**ADDENDUM NO. 3**

**March 04, 2025**

**RE: Pendleton County Fire Station  
2663 HWY US 27 N.  
Falmouth, Kentucky 41040  
Project No. 24056**

**FROM: Brandstetter Carroll Inc.  
2360 Chauvin Drive  
Lexington, Kentucky 40517  
Phone 859-268-1933  
Fax 859-268-3341**

**C-201**

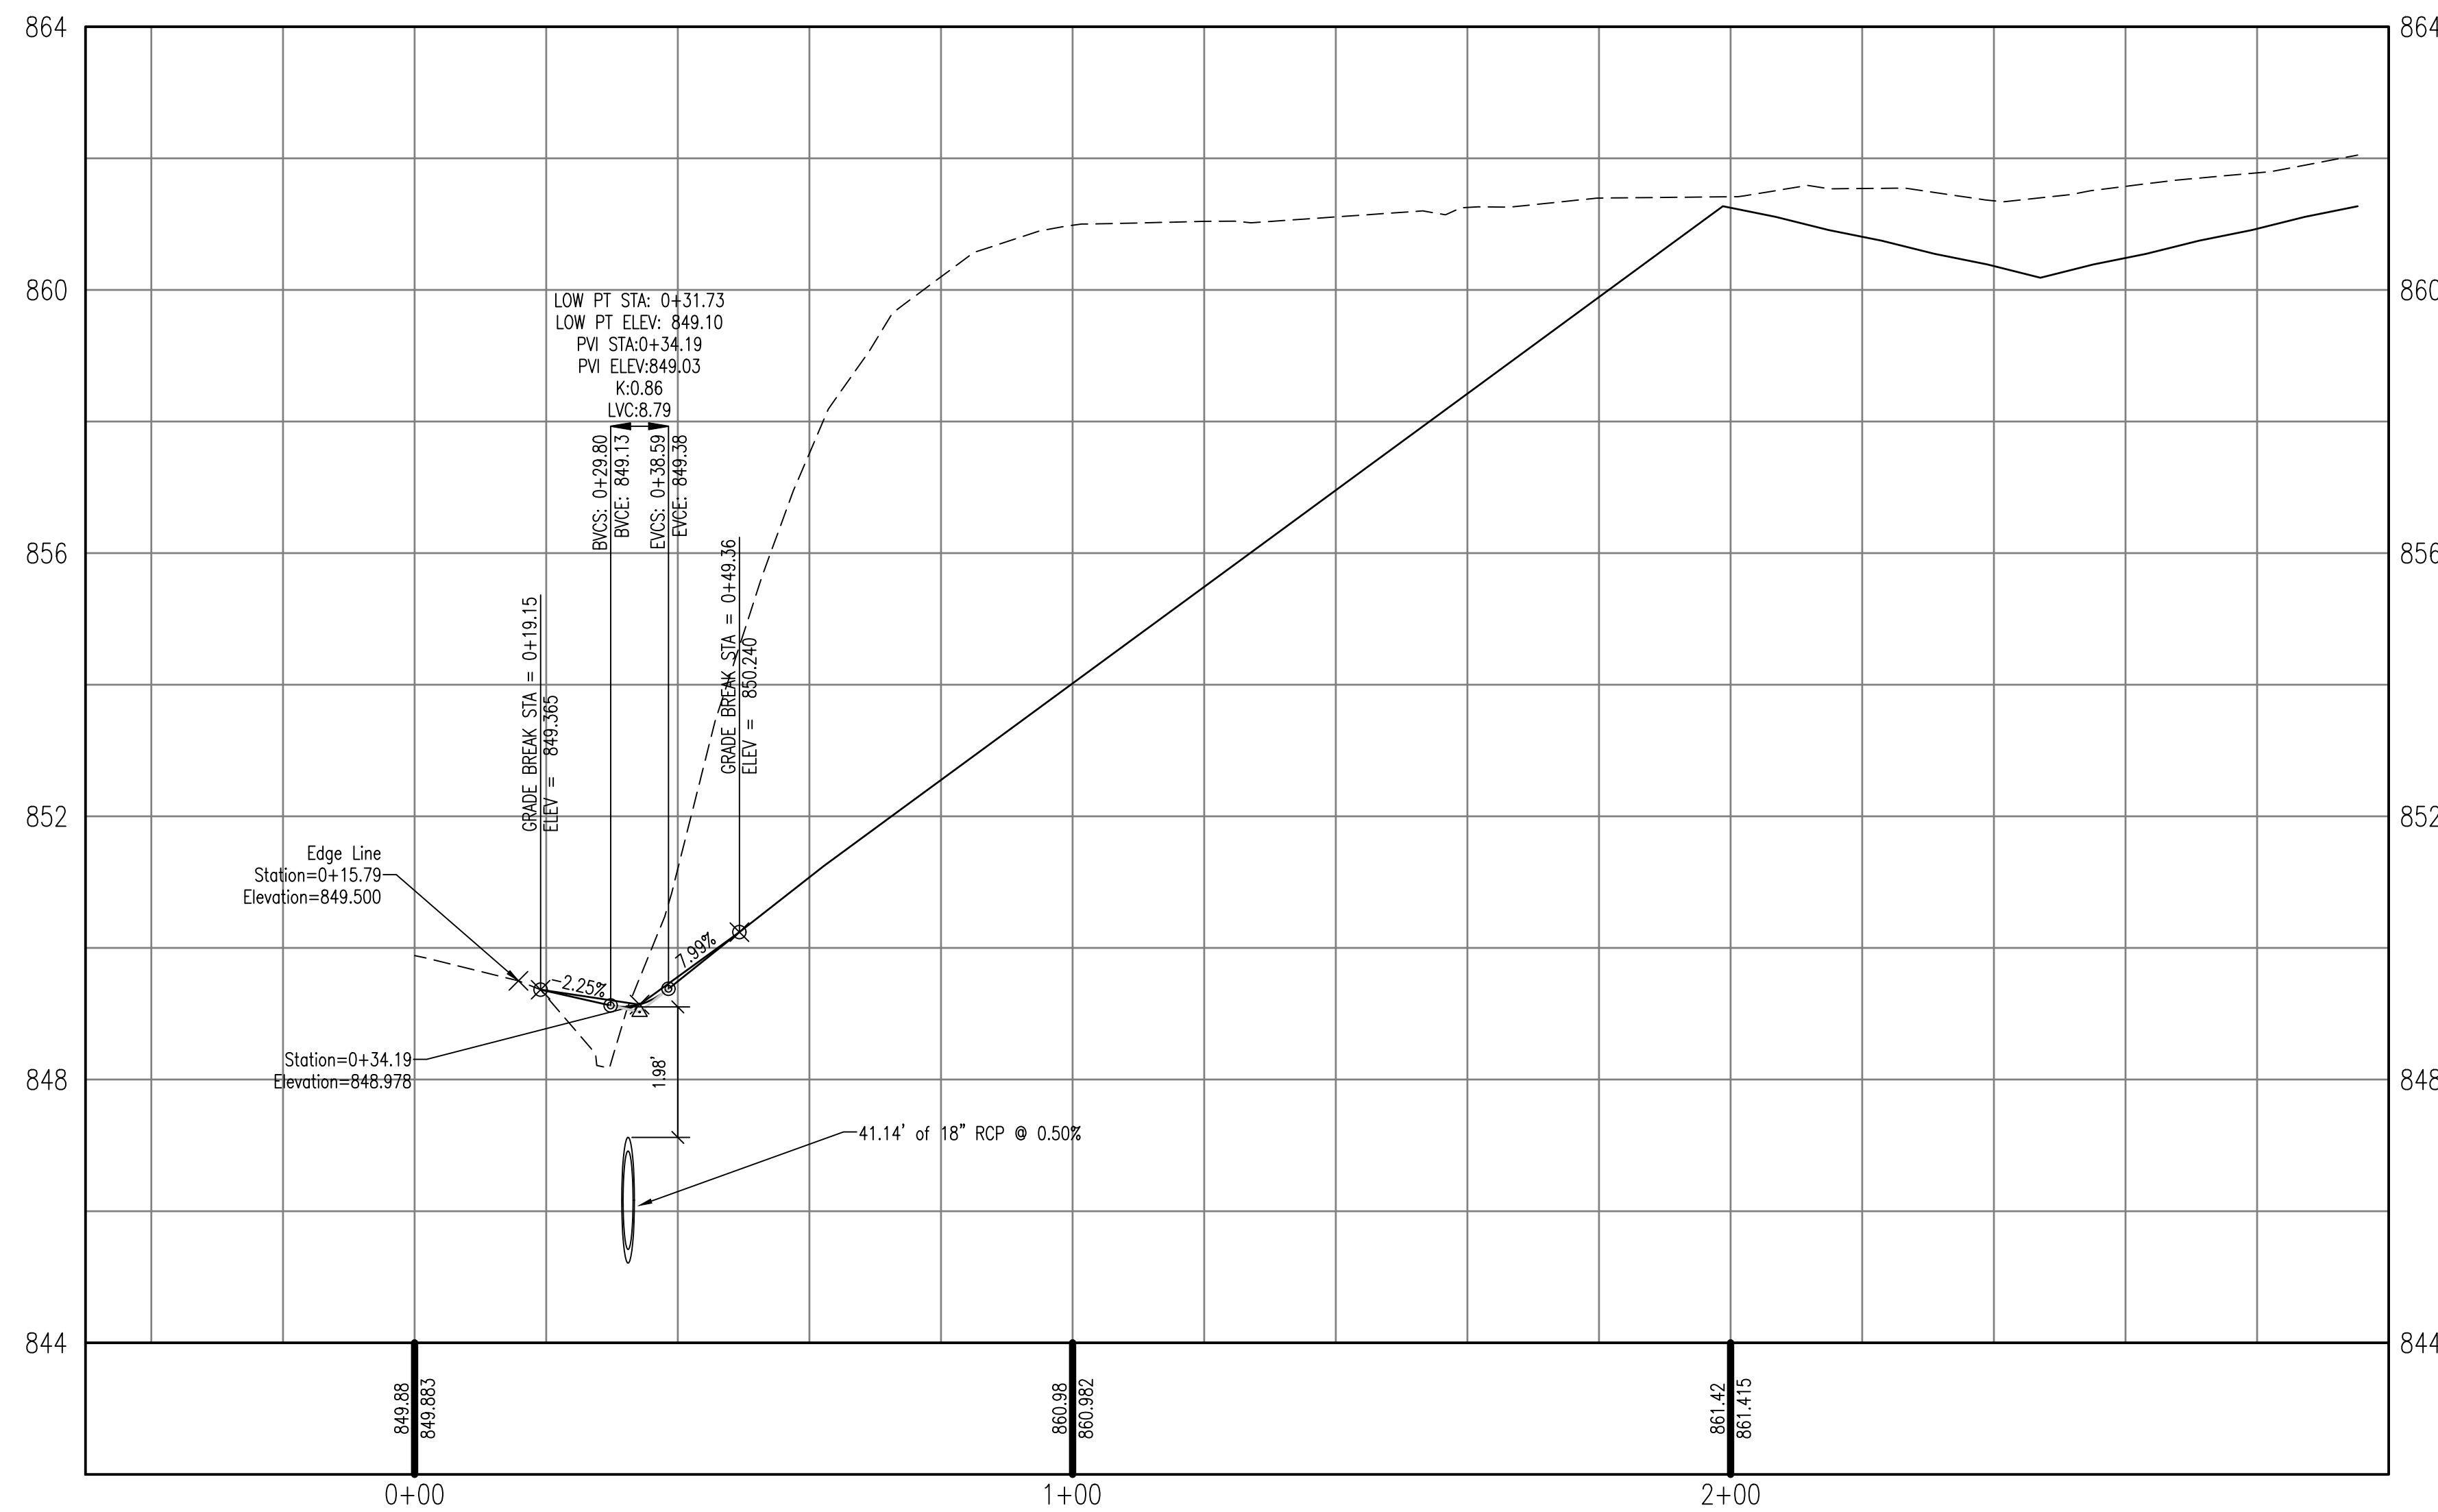
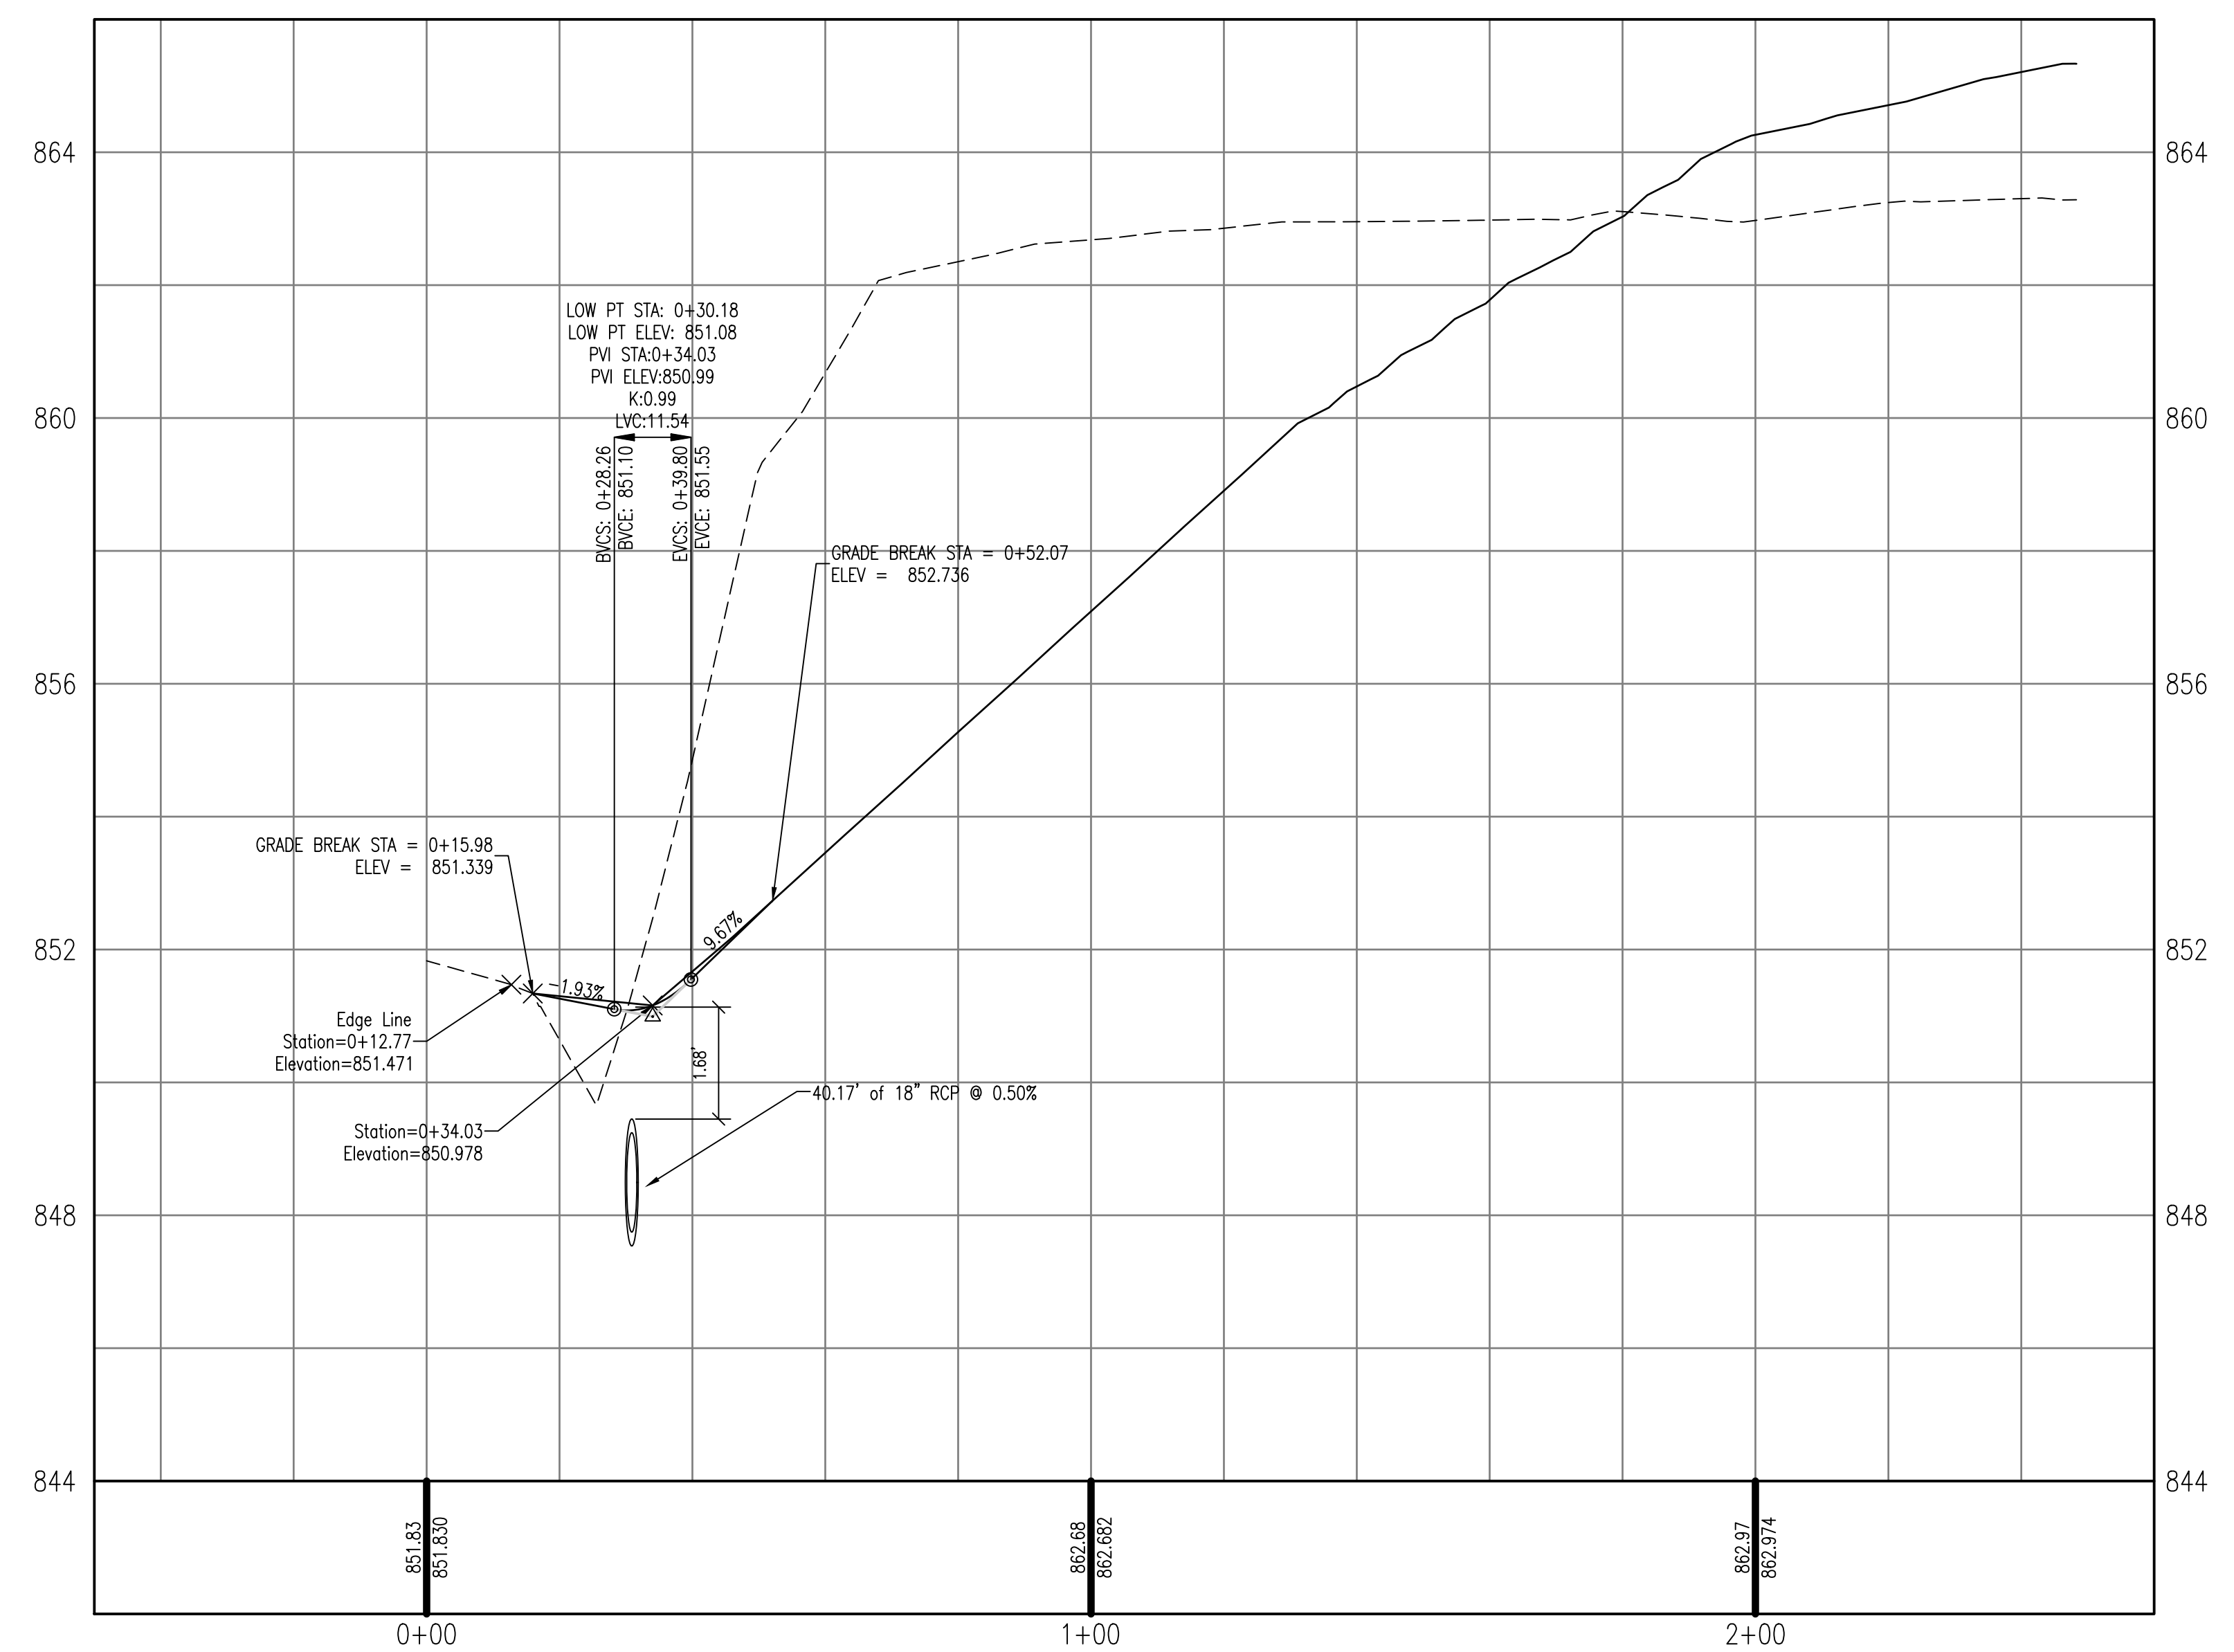
- a. Adjusted helipad and septic field locations.
  - b. Updated legend and coded notes.
  - c. Revised sanitary, gas and water.
- 6. Sheet C-201 Road Profiles:
  - a. Revised sanitary line.
- 7. Sheet C-501 Site Details:
  - a. Revised the printing scale only for both headwall details.
- 8. Sheet E100 Site Electrical Plan:
  - a. Revised conduits for future monument sign and to the Helipad.
- 9. Sheet E501 Site Electrical Schedules:
  - a. Revised light fixture schedule.
